PacifiCorp - Stakeholder Feedback Form

2019 Integrated Resource Plan

Energy Storage Capacity Contribution

Figure 2: Event Duration Histogram

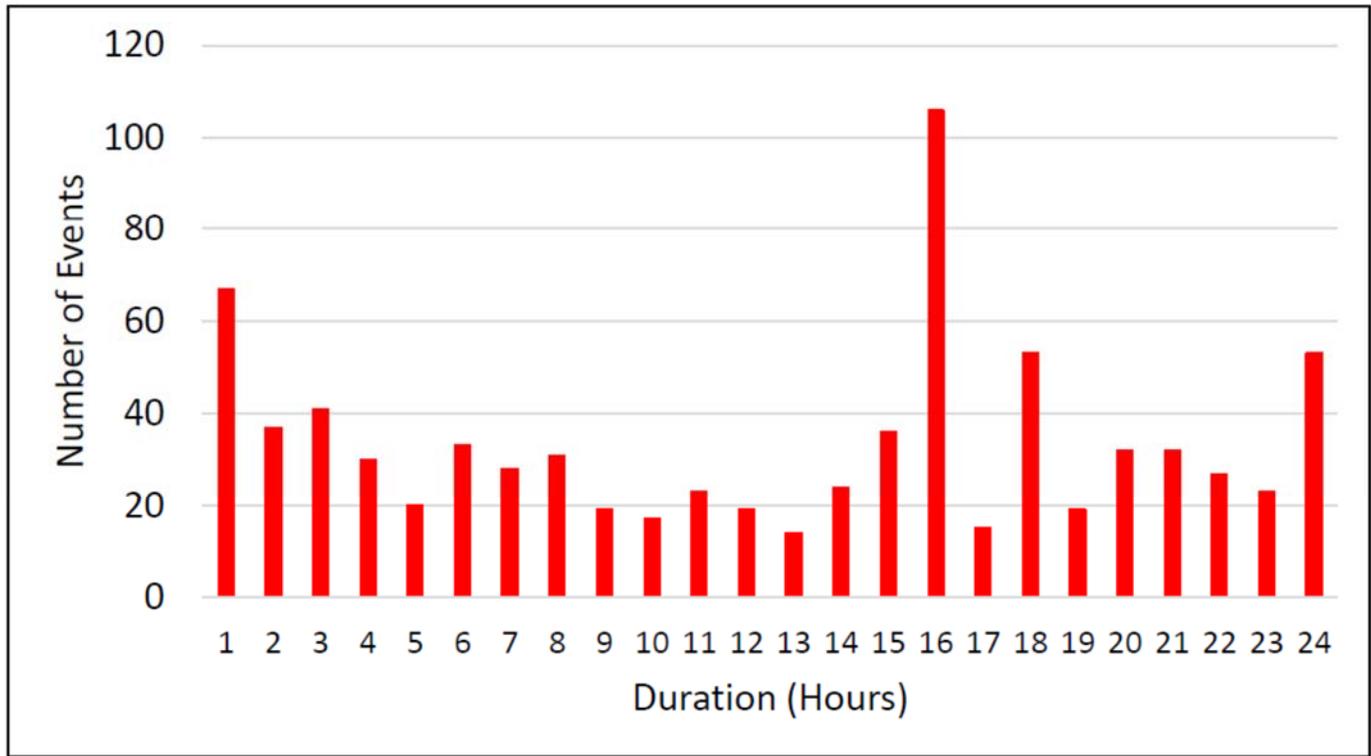
Finally, it is unclear the extent to which the stochastic simulations address low hydro conditions. The test year is based on normal conditions, including hydroelectric supply. Hydro conditions can vary significantly from year to year. Supply adequacy is most at risk during low hydro years and capacity shortfalls can occur over extended periods. The Northwest Power Conservation Council's "NW Power Supply Adequacy Assessment for 2023," which models river volume as a random variable, found that the average load curtailment duration was 21 hours. Figure 2 from the report shows the distribution of load curtailment events by duration.

As seen above, outages of up to 4 hours represent less than 20% of the 1,018 total curtailment events (events over 24 hours are not depicted on the chart). The most common event duration is 16 hours, but this is because the hydroelectric system's output is adjusted, whenever possible, to spread any anticipated unserved energy across all 16 peak hours of the day (e.g., a 2-hour shortage of 800 MW becomes a 16-hour shortage of 100 MW). However, even if all 16-hour events are assumed to be 4 hours or less before smoothing, the outages of up to 4 hours represent just 25-30% of the total. Increasing the storage duration to 10 hours captures 40-45% of the events (~50% more than the 4-hr battery). These results suggest that, even before considering fossil retirements, PacifiCorp's application of the CF Method may be overestimating the ability of 4-hr storage to address future capacity shortfalls and avoid curtailment events.

We are concerned that if the CF Method is overestimating the capacity contribution of 4-hr batteries versus longer-duration pumped storage, these assumptions may be introducing a bias to System Optimizer and that the resulting portfolios may not include any pumped storage. Since we expect that the benefits of longer-duration storage are more likely to be revealed through application of the Planning and Risk (PaR) model, it would be unfortunate if pumped storage were not considered at that stage of analysis, especially when explicitly modeling significant retirements of coal-fired generation. As an alternative to performing a more extensive analysis of capacity contribution, we would appreciate PacifiCorp including sensitivities in which a portion of the new capacity is provided by pumped storage resources so that the PaR results can be compared to the results for portfolios produced by System Optimizer without that constraint.
